ATTENDED PLAN SHOWING ADDITION OF EXTRA BAY TO NORTH WING.

WELLINGTON CENTRAL LIBRARY.

DRAWING NO. O.

NOTE: AN ADDITIONAL BAY IS TO BE INTRODUCED IN THE LENGTH OF THIS NORTH WING AS INDICATED ON THE AMENDED PLAN DRAWING NO. O.
THIS WILL BE A COMPLETE MODIFICATION OF THE BAY INCLUDED WITHIN THE RECTANGLE A B C D.

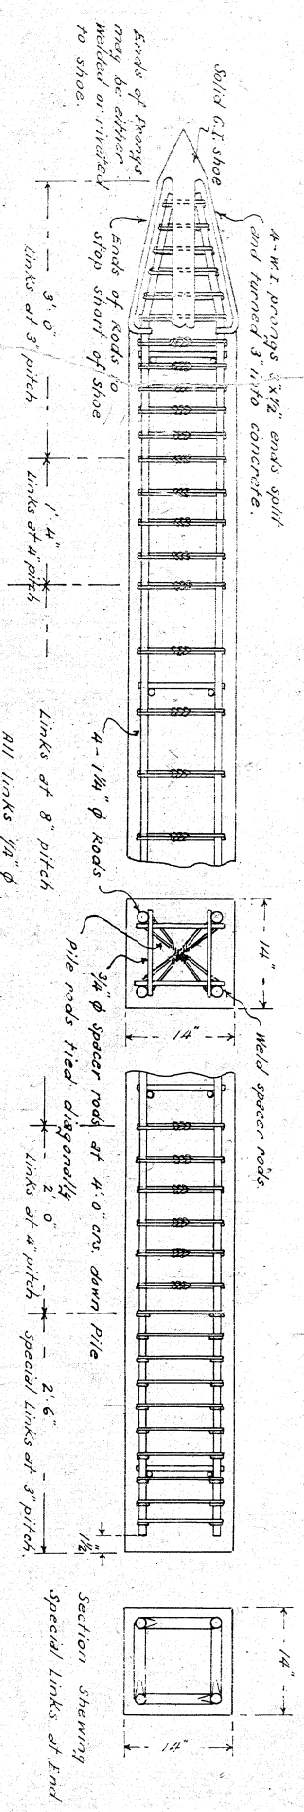
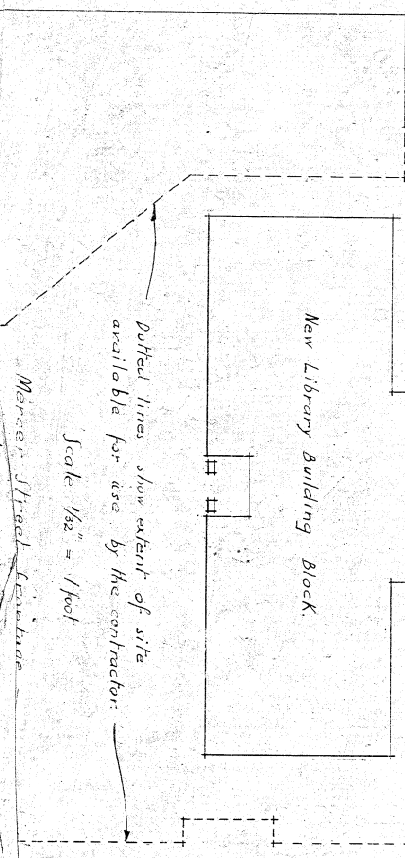
NOTE: Footings to Column 117A & 122A to be as for footing to Column 117.

NOTE: Additional bay also includes roof beams 3, 35 & 46 and supports beams 35, 33 & 32 to low roof over Lending library.

GROUND FLOOR PLAN

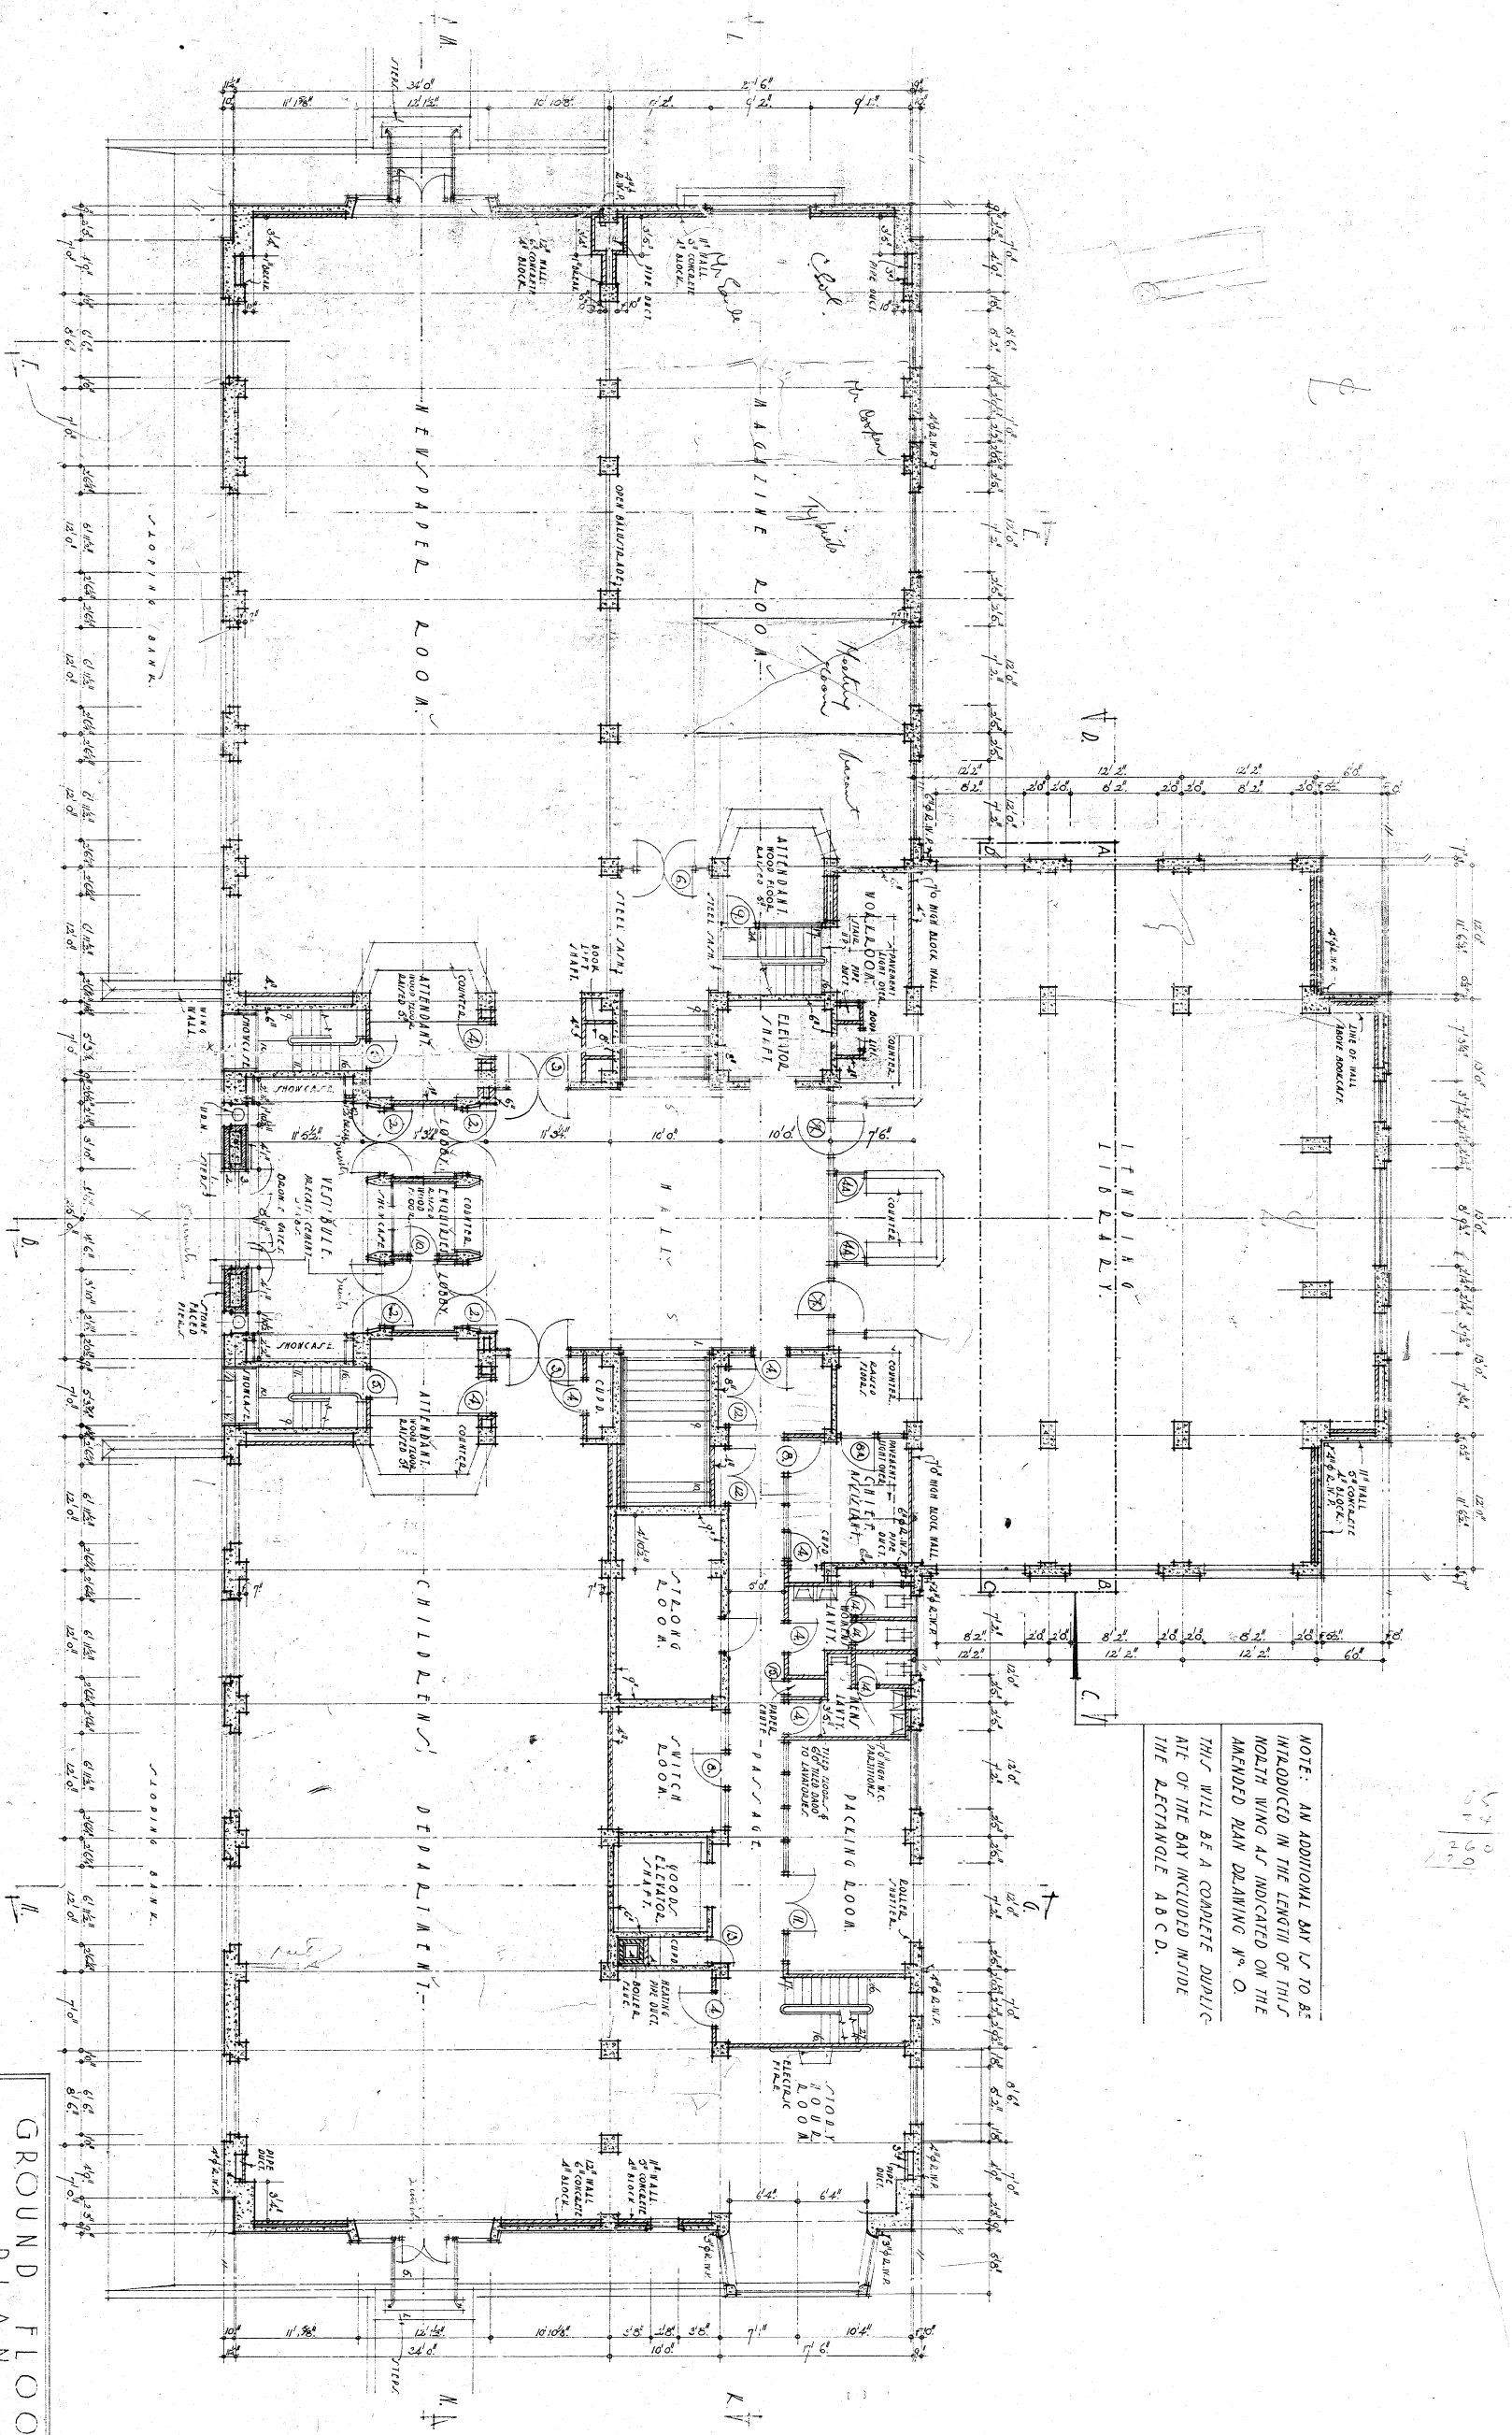
NOTE: AN ADDITIONAL BAY UP TO BE INTRODUCED IN THE LENGTH OF THIS NORTH WING AS INDICATED ON THE AMENDED PLAN DRAWING N° O. THIS WILL BE A COMPLETE DUPLICATE OF THE BAY INCLUDED INSIDE THE RECTANGLE A B C D.

MEZZANINE FLOOR
 PLAN.

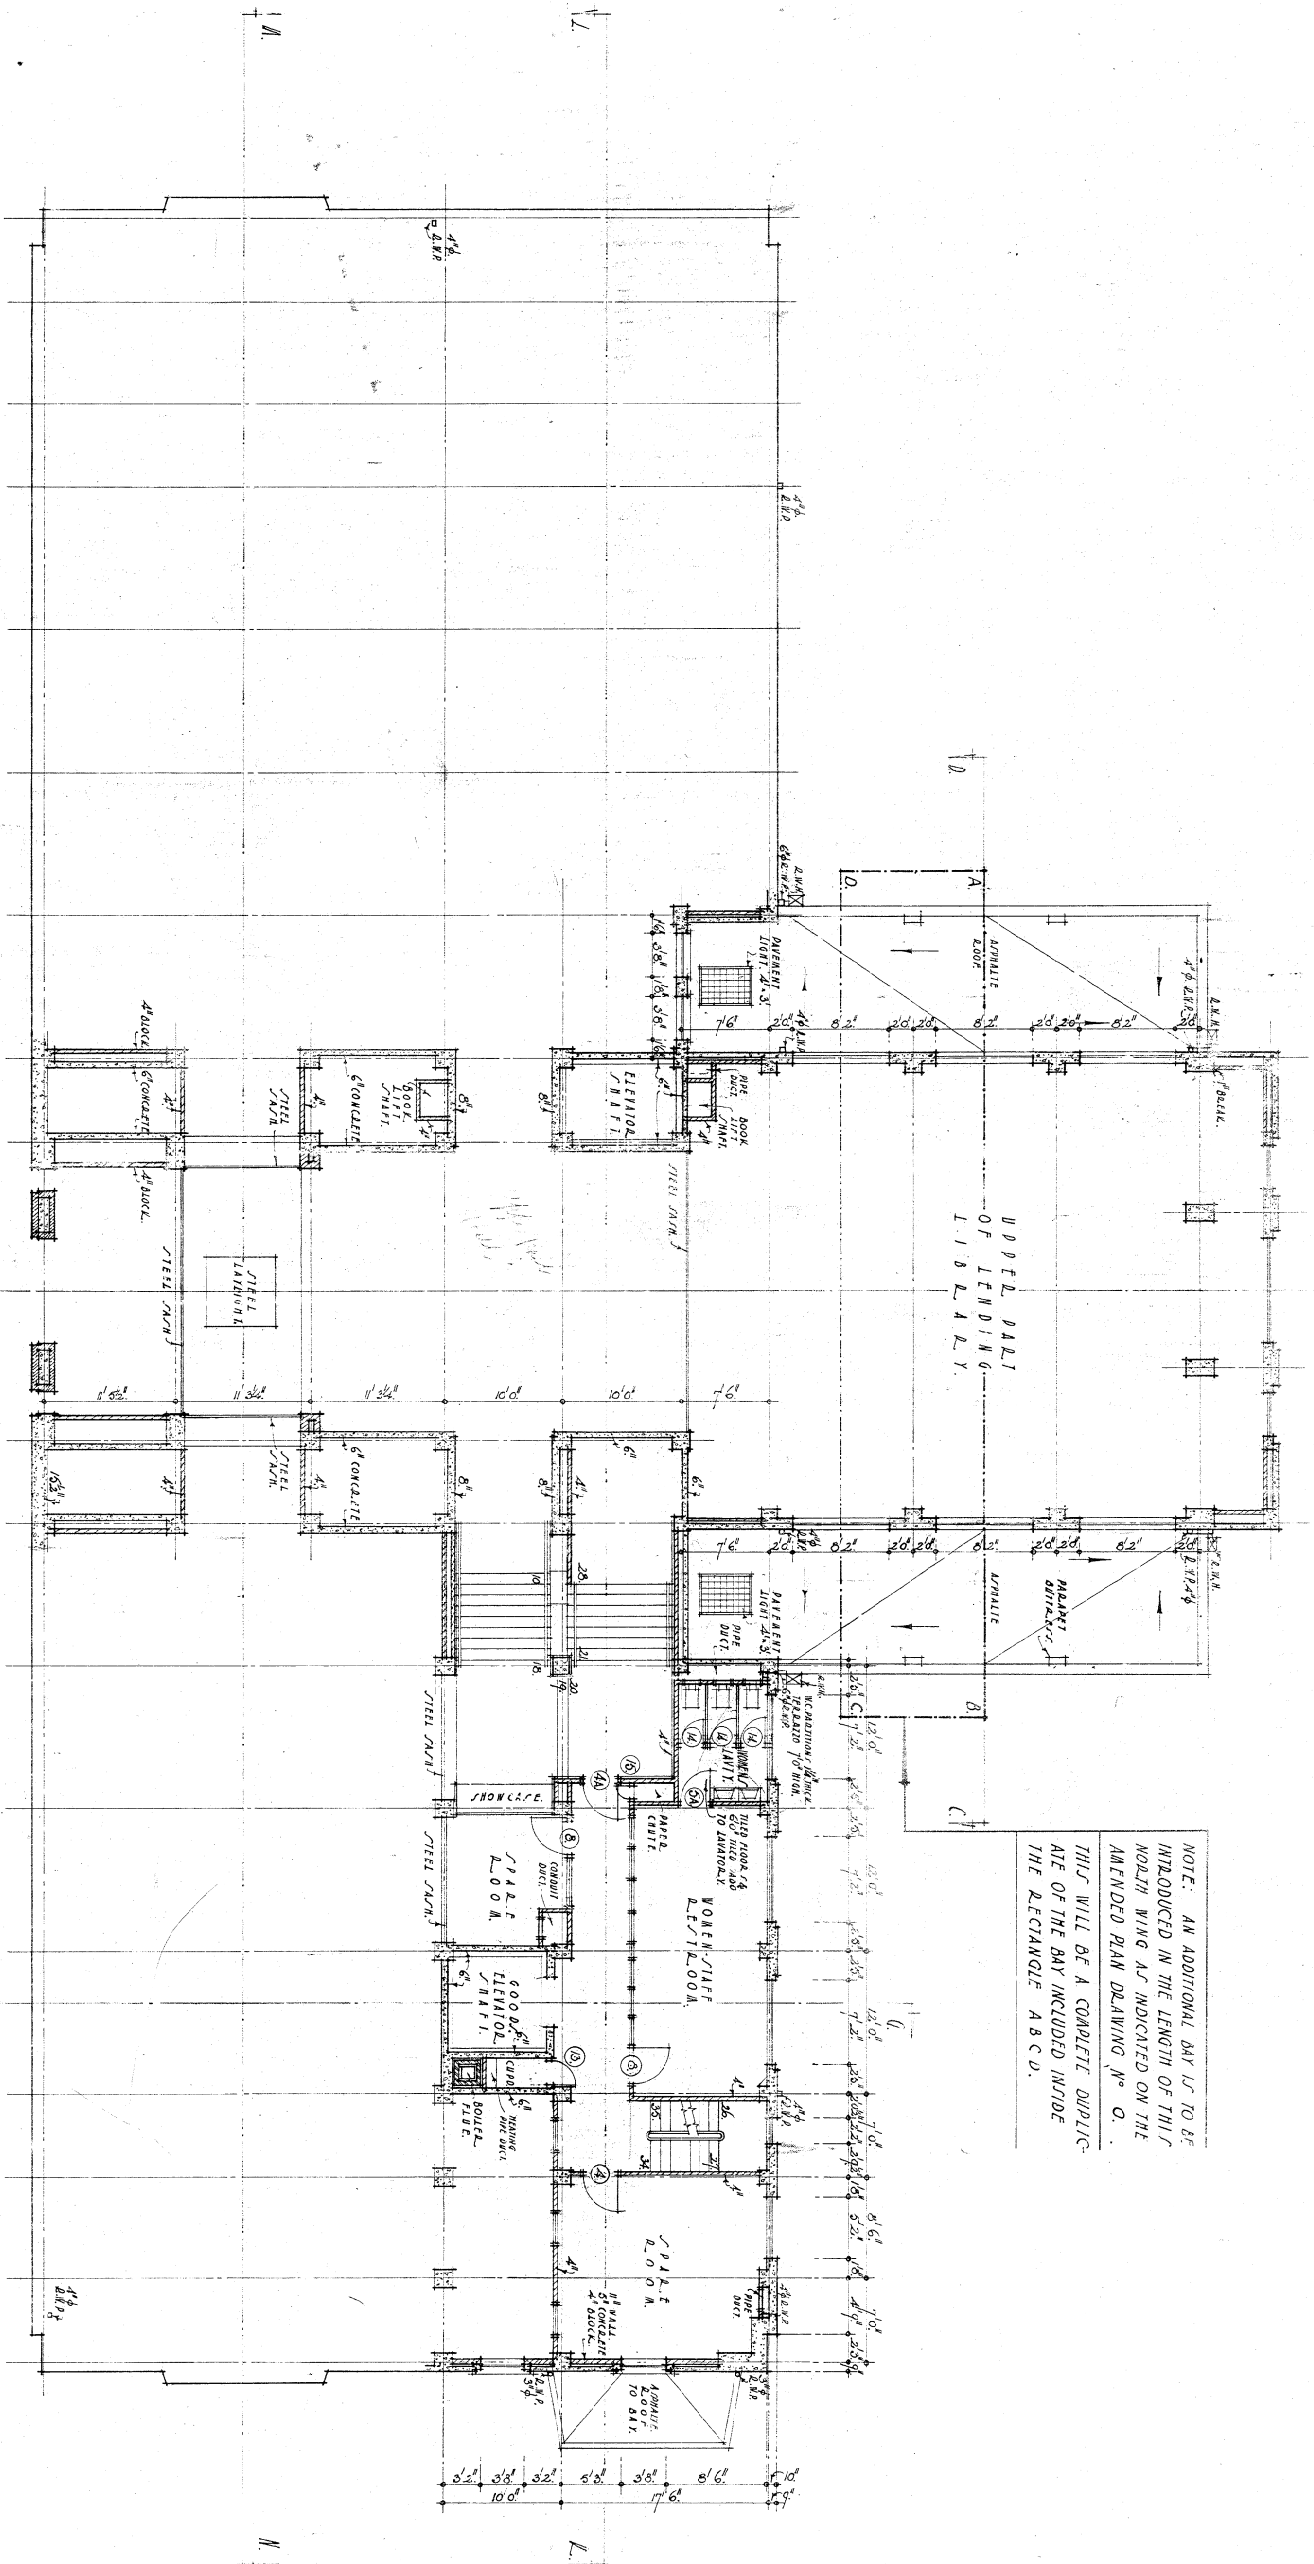
NOTE: AN ADDITIONAL BAY IS TO BE INTRODUCED IN THE LENGTH OF THIS NORTH WING AS INDICATED ON THE AMENDED PLAN DRAWING NO. O. THIS WILL BE A COMPLETE DUPLICATE OF THE BAY INCLUDED INSIDE THE RECTANGLE A B C D.
